IN THE MATTER OF an Application by Hydro One Networks Inc. pursuant to section 92 of the Act, for an Order or Orders granting leave to construct a transmission reinforcement project between the Bruce Power Facility and Milton Switching Station, all in the Province of Ontario.

AFFIDAVIT

WHITFIELD A. RUSSELL

THE SAUGEEN OJIBWAY NATIONS

Figure 1
Hydro One Transmission Capacity with Near-Term Upgrades and New Line

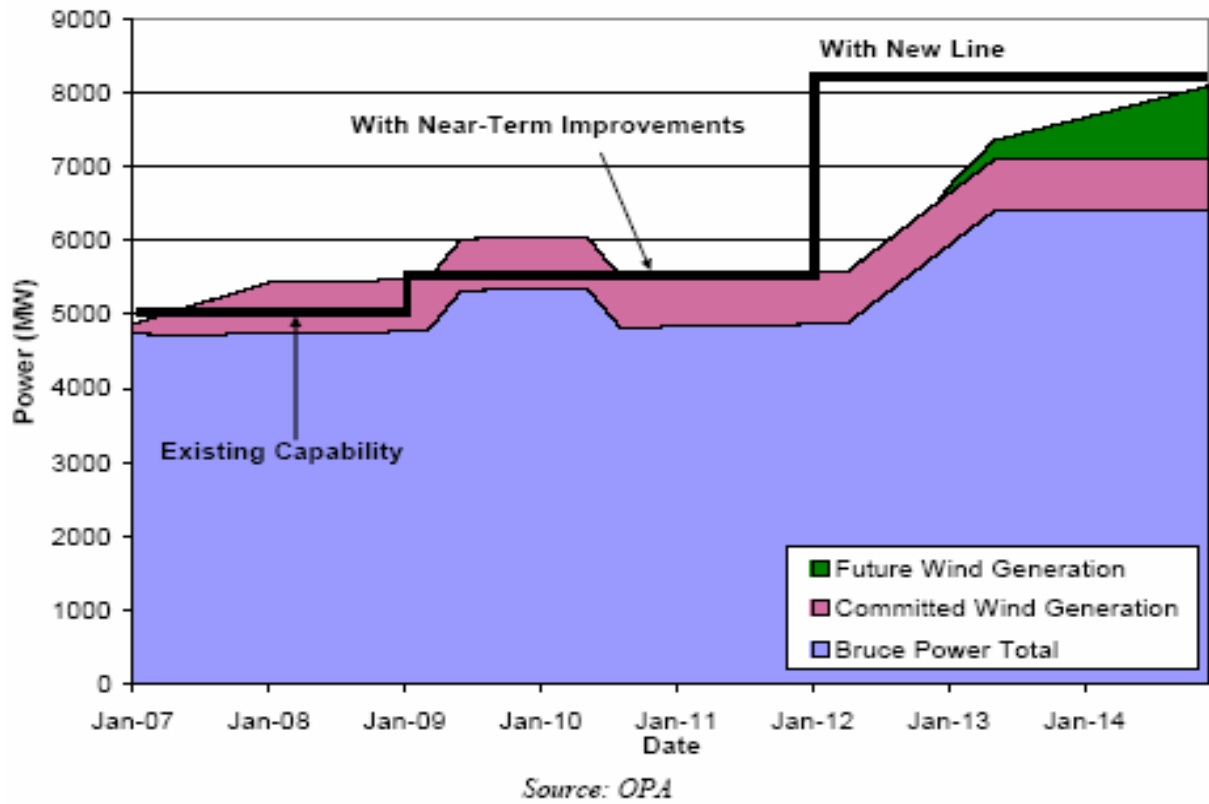
9. It is critical to note that in its assessment of the need for its proposed project, Hydro One, relying on OPA analysis and reports, has included two significant sources of generation that have not been approved or committed. First, Hydro One has included 1000 MW of potential wind generation from the Bruce region that has been identified in the IPSP. Second, Hydro One has included in its analysis 4 refurbished Bruce B units with an estimated combined output of approximately 3400 MW. The inclusion of these two unapproved and uncommitted sources of generation has fundamental implications both as a justification for the proposed project from a system design perspective, as well as for the economic evaluation of the project and other reasonable alternatives.

10. A proper need analysis ought to be based on existing and committed generation from the Bruce area. Removing the two major sources of unapproved and uncommitted generation that have been included in Hydro One’s analysis results in a picture of the transmission facilities that are required to service the Bruce area dramatically different from that conveyed by Hydro One. This difference is evident when comparing Hydro One’s graphic representation of the need for the new line, shown in Figure 1, to my analysis, shown as Figure 2. As can be seen in Figure 2, the amount of generation that needs to be accommodated in the Bruce area never exceeds 7000 MW, using actual existing ratings and removing uncommitted generation.

S.O.N. Analysis of Committed Capacity

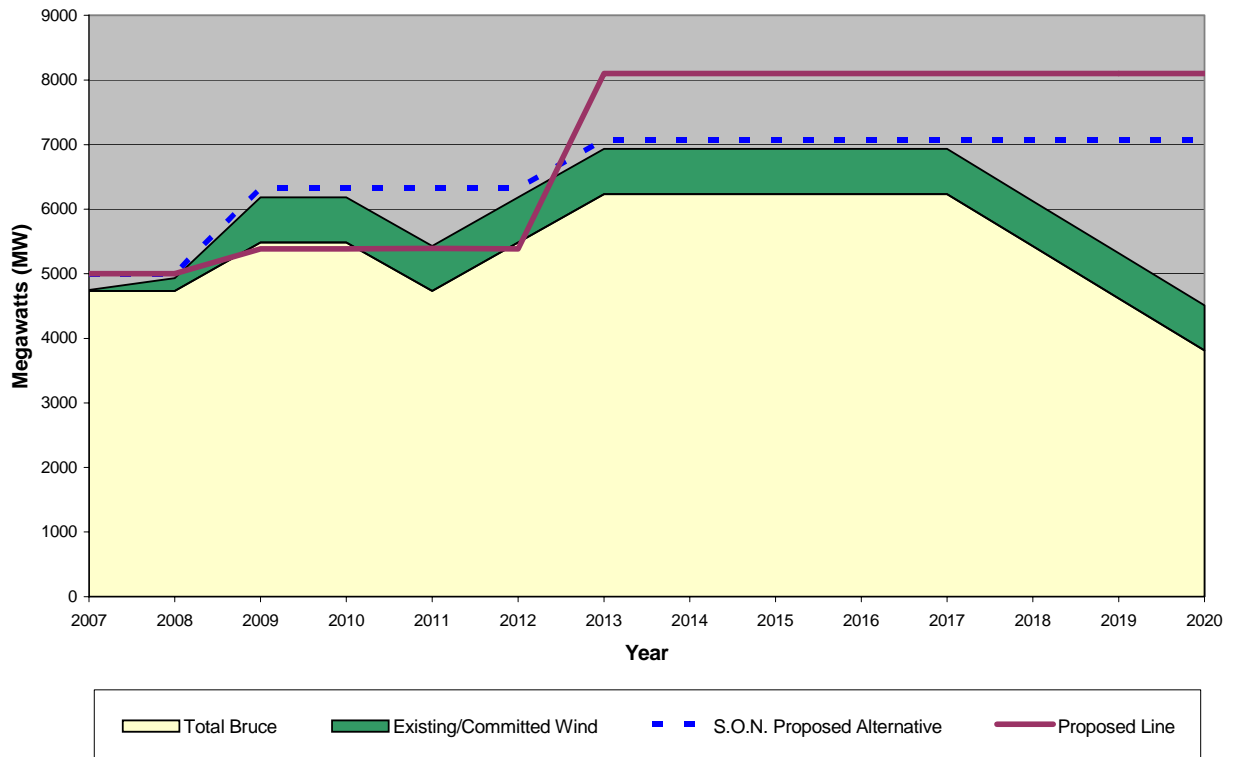
11. My analysis of the need for transmission upgrades is based on the actual existing and committed generation planned for the Bruce area as described in filed evidence in this matter. My analysis indicates that, while some transmission enhancement is required in order to serve all of the approved generation capacity in the Bruce area, the proposed Bruce-Milton Lines are neither the most economic nor the best suited upgrades for the amount of capacity actually committed at this time.
12. Given the several alternative scenarios for expanding generation from the Bruce region that may possibly develop in the future, any transmission project chosen now should be sufficiently scalable to accommodate various future scenarios. As

13. According to the revised filing, there is approximately 4734 MW of capacity at the Bruce NGS. Also, there is approximately 15 MW of existing wind generation in the vicinity of the Bruce area. This combined capacity of the existing nuclear and wind generation capability totals 4750 MW, 250 MW less than the 5000 MW of average generation capacity and minimum transmission transfer capability that OPA and Hydro One cite as currently existing. See Hydro One's Application, Exhibit B, Tab 1, Schedule 1, p. 3 and Exhibit B, Tab 6, Schedule 5, Appendix 1, p. 3. During the Technical Conference, an OPA representative stated that the existing generation in the vicinity of the Bruce Complex has an installed capability of 4749 MW. Exhibit No. 4 at p. 15.

17. In contrast to the contentions of OPA and Hydro One that an additional 3100 MW (for a total of 8100 MW) of transfer capability is required, this chart shows that the needed amount of future transfer capacity is smaller. As noted above, Hydro One states that existing transmission capacity equals approximately 5000 MW. Using these assumptions, my calculations indicate that there will be a shortfall of approximately 1200 MW in 2009-2011, and approximately 1950 MW by 2013. This shortfall of approximately 2000 MW will last only until 2018, at which time the Bruce B units will begin to retire unless further commitments are made.
